**Subject: Section 8 of the Red Hill Administrative Order on Consent ("AOC")
Statement of Work ("SOW") Approval of Section 8.3 and Requirement to
Complete Additional Work**

Subject: Honolulu Board of Water Supply (BWS) Comments on ABS Consulting (ABS) Report "Quantitative Risk and Vulnerability Assessment Phase 1 (Internal Events without Fire and Flooding) dated November 12, 2018" and "Navy's Risk and Vulnerability Assessment Summary" and Cover Letter dated May 29, 2019 as per Red Hill Bulk Fuel Storage Facility (RHBFSF) Administrative Order on Consent (AOC) Statement of Work (SOW) Section 8

General Comments on Phase 1 QVRA Report

Source: NAVFAC, 2019c – First Quarter 2019 – Quarterly Groundwater Monitoring Report, Red Hill Bulk Fuel Storage Facility, Joint Base Pearl Harbor-Hickam, Oahu, Hawaii. May.

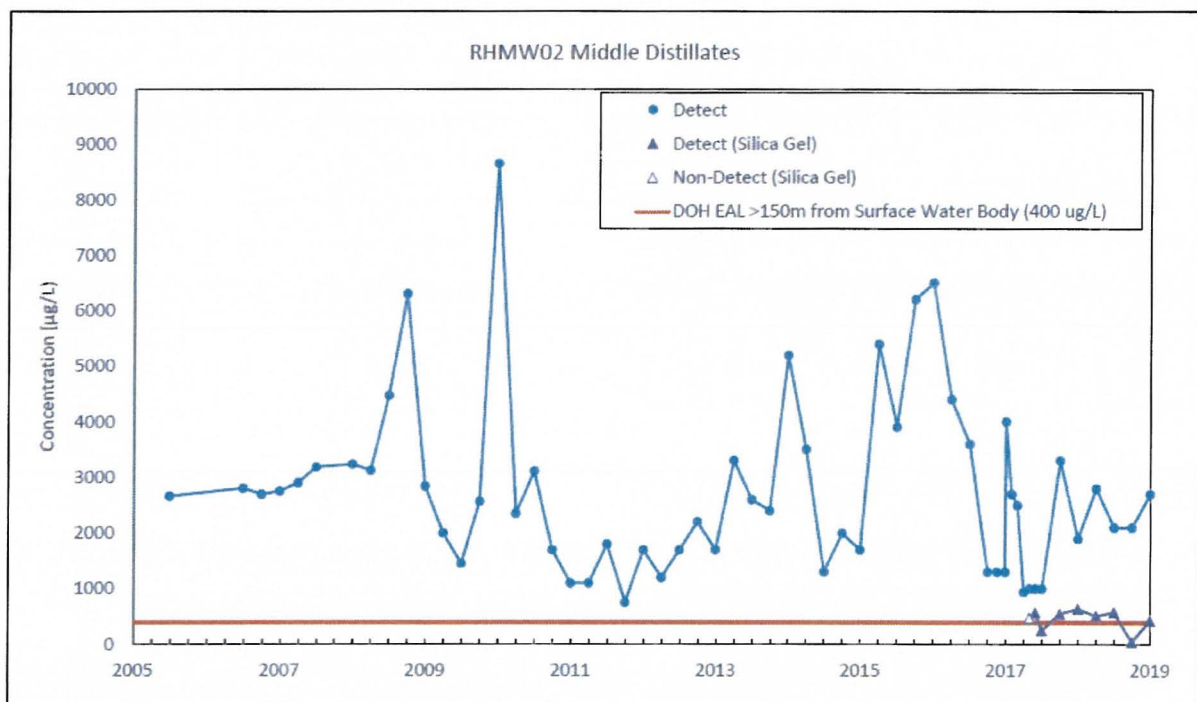
Groundwater data indicates that fuel continues to migrate to groundwater. As shown in the graph below, fuel constituents have been identified in groundwater samples collected from monitoring well RHMW02 since 2005. RHMW02 is the monitoring well located in the approximate center of the lower access tunnel and midpoint of the RHBFSF tank farm.
